UNITED STATES PATENT AND TRADEMARK OFFICE

APPLICATION NO.	FILING DATE	FIRST NAMED INVENTOR	ATTORNEY DOCKET NO.	CONFIRMATION NO.
10/646,643	08/22/2003	George William Dailey	2003P07970 US	9785
7590	10/27/2005			
Elsa Keller Siemens Corporation Intellectual Property Department 170 Wood Avenue South Iselin, NJ 08830			EXAMINER AYRES, TIMOTHY MICHAEL	
			ART UNIT 3637	PAPER NUMBER

DETAILED ACTION

This is a final office action on the merits of application SN10/646,643.

King '090 Fig. 1

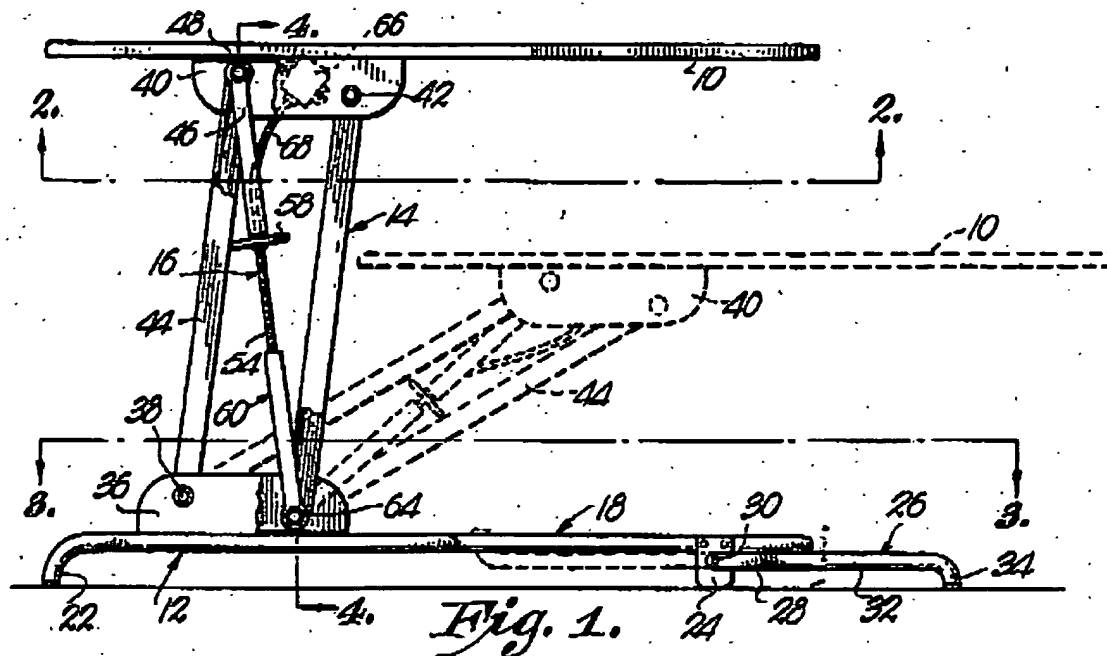
6. Claims 1-4 and 8 are rejected under 35 U.S.C. 102(b) as being clearly anticipated by U.S. Patent 3,288,090 to King. King '090 discloses an elongated planar member (10) that has a top and bottom side and inherently can support a patient. A support assembly (12) includes a base (18) that defines the base plane and a pedestal (36) disposed on the base (18). A plurality of elongated connecting arms (14), with a first end defined by pins (42) and a second end defined by pins (38). The first end of the elongated members (14) is pivotally attached through pins (42) to the bottom of the planar member (10) through flange (40). The second end of the elongated members (14) is pivotally attached through pins (38) to the base pedestal (36). The planar member (10) moves from a first position to a second position as shown in figure 1 with the elongated members (14) traveling through an axis that is orthogonal to the base.

7. The means for moving the planar member from the first position to the second position is a motor assembly (66, 68) with a screw member (54), which connects to the pins (38,42) and the connecting arms. The plane of the first position and the plane of the second position are parallel to each other and the base plane as shown in figure 1. The plurality of elongated members (14) is arranged in a four bar linkage.

King '090 Figure 1

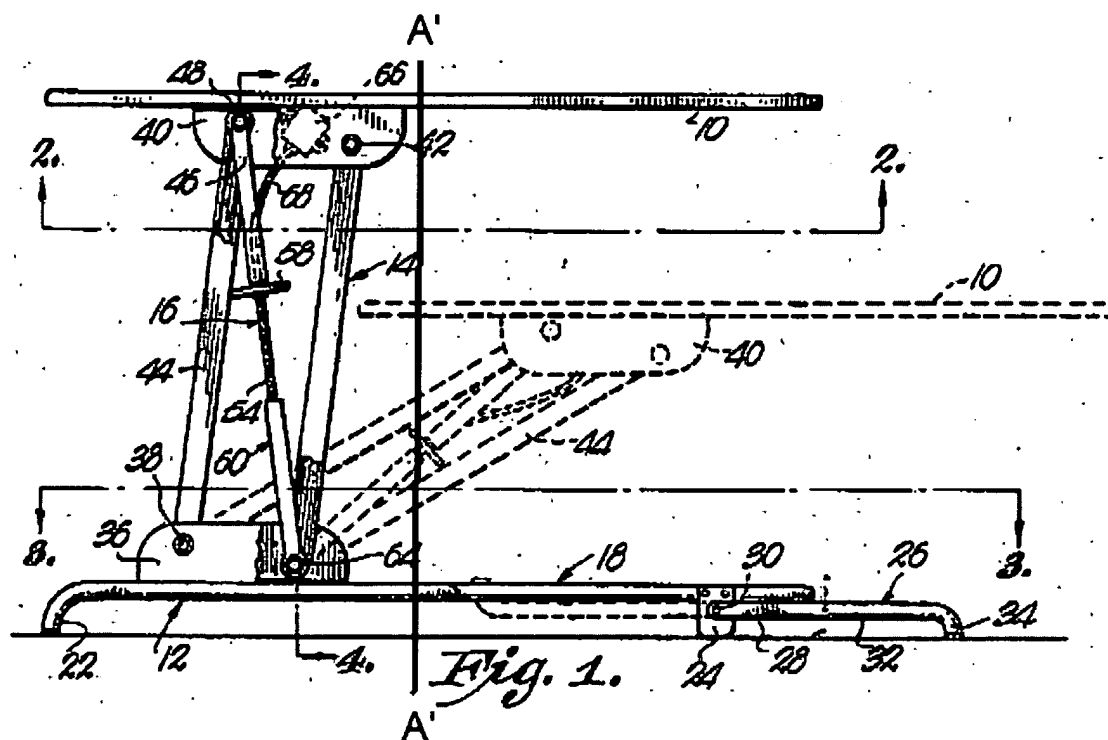
18. In response to applicant's argument that U.S. Patent 3,288,090 to King is nonanalogous art, it has been held that a prior art reference must either be in the field of applicant's endeavor or, if not, then be reasonably pertinent to the particular problem with which the applicant was concerned, in order to be relied upon as a basis for rejection of the claimed invention. See *In re Oetiker*, 977 F.2d 1443, 24 USPQ2d 1443 (Fed. Cir. 1992). In this case, King '090 solves the problem of moving a planar object in multiple vertical positions. King '090 is capable of supporting a patient, since the definition of a patient is anyone who needs medical attention, a baby can be included as anyone who needs medical attention and even some babies can weigh less than an iron does.

19. Regarding the argument that the parallel linkage of King '090 does not travel through an axis that is orthogonal to the base. It is impossible for a connecting arm that has a solid pivot and some width to travel completely through any axis as implied by the applicant's interpretation of claim 1. It is interpreted by the examiner that each connecting arm just has to travel across one axis orthogonal to the base as shown in the marked up figure 1 below with axis A'-A' and not that an axis of the connecting arm has to be orthogonal at some point in the travel of the connecting arm or that the angle of attack has to be 90 degrees as used in the applicants argument on page 10 of the remarks filed received on 10/06/05 even though it does not appear in the claims.
